# SAFETY RECALL

October 2011

A small number of 2012 Trek bicycles were made with a saddle clamp bolt, on the seat post, that exhibits hydrogen embrittlement. This is a list of the affected models:

Figure 1. Nebula seatpost showing saddle clamp bolt

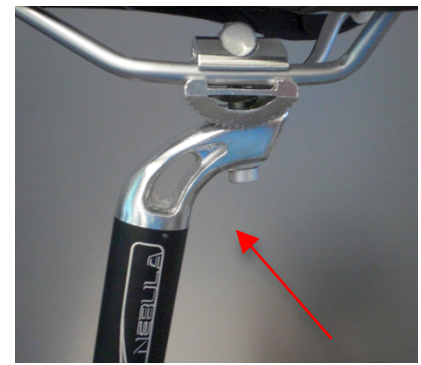
Hydrogen embrittlement could allow the saddle clamp bolt to break, which could allow the saddle to come off the seat post unexpectedly. If this happens, the rider could fall and possibly be injured. Your safety is very important to us. Therefore, Trek will replace the saddle clamp bolt on an affected bicycle, free of charge.

If you own a bicycle that is affected by this recall, Trek will provide you—through your Trek dealer—a free replacement of the saddle clamp bolt on your bicycle. If you have any questions, please contact your dealer, or call Trek at the special recall hotline:
